Date 8/26/91NAME OF PROPOSED DEVELOPMENT VIDEO VILLAGE INC.

FINAL PLAT
Lot 3, Block 1
Steger Retail Addition
City of Rockwall, Rockwall County, Texas

VIDEO VILLAGE

RE: Site Plan for the Video Village Development

LOT 3, BLOCK 1
STEGER RETAIL ADDITION

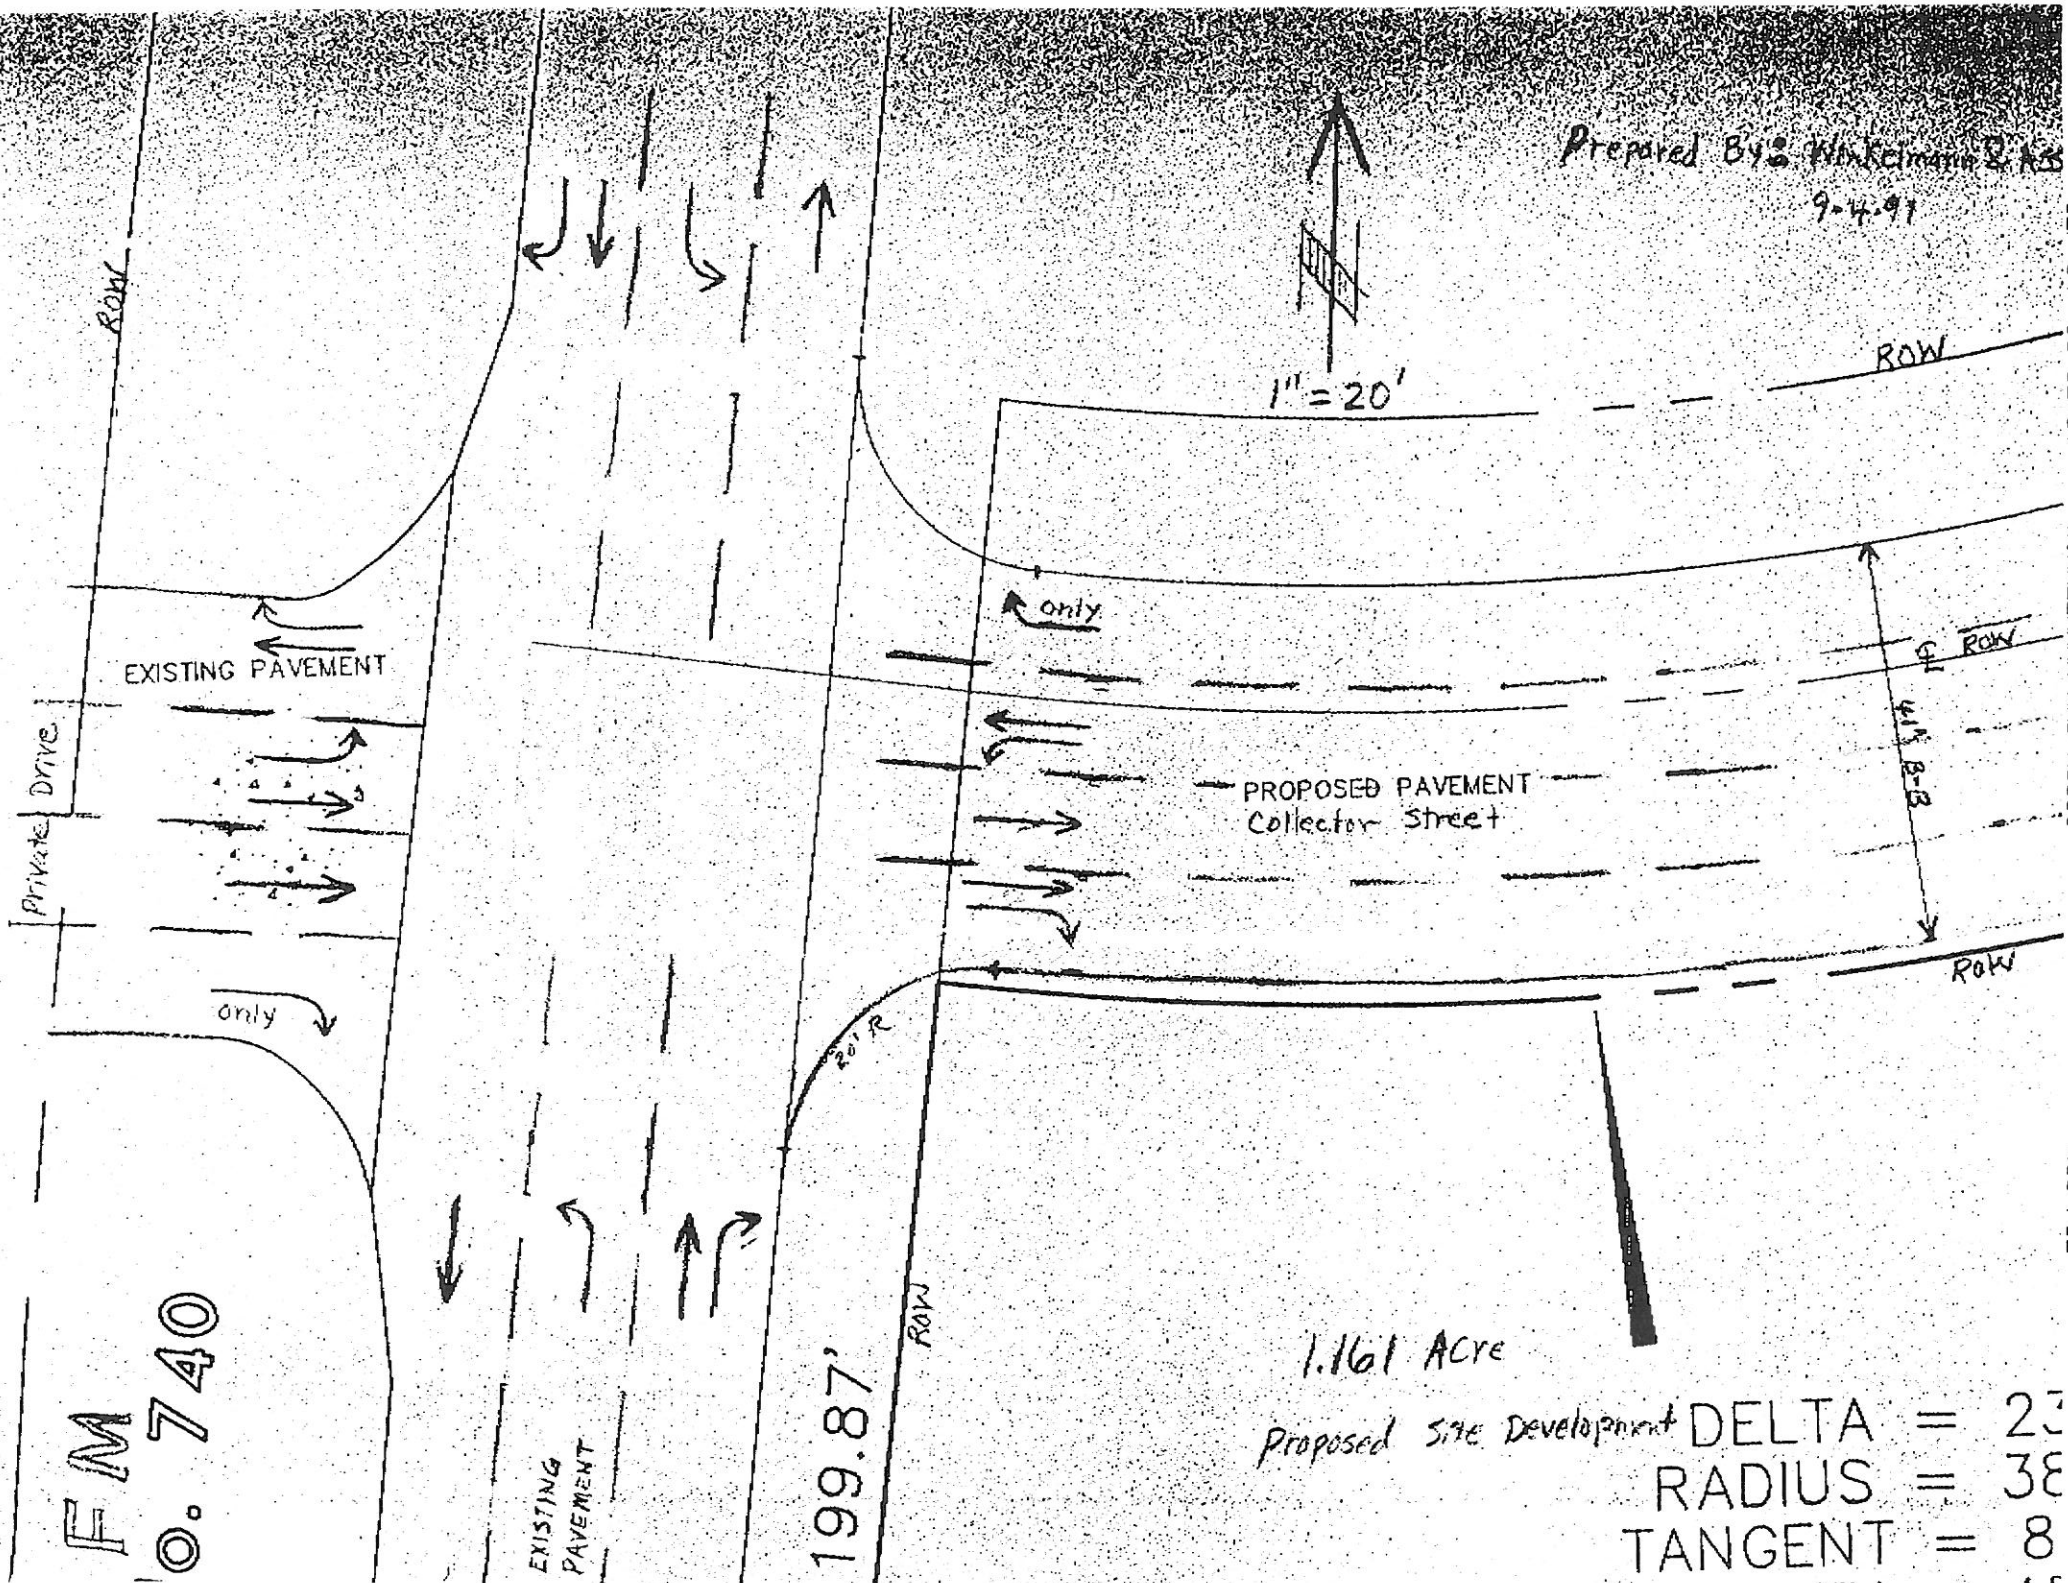
1. need application ~~with fee~~

2. need Road name

3. need 10' easement or 60' collar

4. need to redo opposite utility easement

4. Cross access easements need to be placed on
the plat on the drive in front of the
store and on the driveway to the rear
